Access Compliance Report Public Rights-of-Way (Curb Ramps)

Main Street: CHIMNEY_LN Cross Street: MAIN_ST Location: NE

ADA ID: RPRK211101131701 Ramp Type: Type 4 - Parallel Initial Pass/Fail: Fail Overall Compliance: No Severity Score: 15

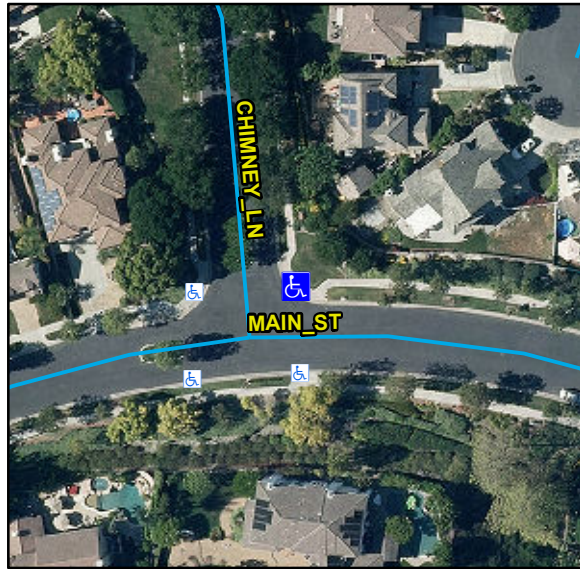
Compliance	Description	Data	Compliance	Description	Data
N/A	Ramp Length LT (in)	108	N/A	Ramp Length RT (in)	113
Yes	Ramp Width LT (in)	53	Yes	Ramp Width RT (in)	53
No	Ramp Run Slope LT (%)	9.6	Yes	Ramp Run Slope RT (%)	4.5
Yes	Ramp Cross Slope LT (%)	1.1	Yes	Ramp Cross Slope RT (%)	1.2
N/A	Landing Present	N/A	N/A	DWS Provided	N/A
N/A	Landing Length (in)	N/A	N/A	DWS Contrast	N/A
N/A	Landing Width (in)	N/A	N/A	DWS Length (in)	N/A
N/A	Landing Run Slope (%)	N/A	N/A	DWS Full Width	N/A
N/A	Landing Cross Slope (%)	N/A		DWS Offset Type	N/A
N/A	Landing Movement Obstructed?	N/A	N/A	DWS Offset Left (in)	N/A
	Landing Movement Type	N/A	N/A	DWS Offset Right (in)	N/A
N/A	Landing Shared	N/A			
N/A	Clear Space	Yes			
N/A	Clear Space To Crosswalk (in)	N/A			
N/A	Marked Crosswalk 1	No	N/A	Marked Crosswalk 2	No
	Crossing 1 Direction	W		Crossing 2 Direction	S
N/A	Marked Crosswalk 1 Width (in)	N/A		Marked Crosswalk 2 Width (in)	N/A

Remove & Replace Curb Ramp With Two New Directional Ramps or Equivalent.
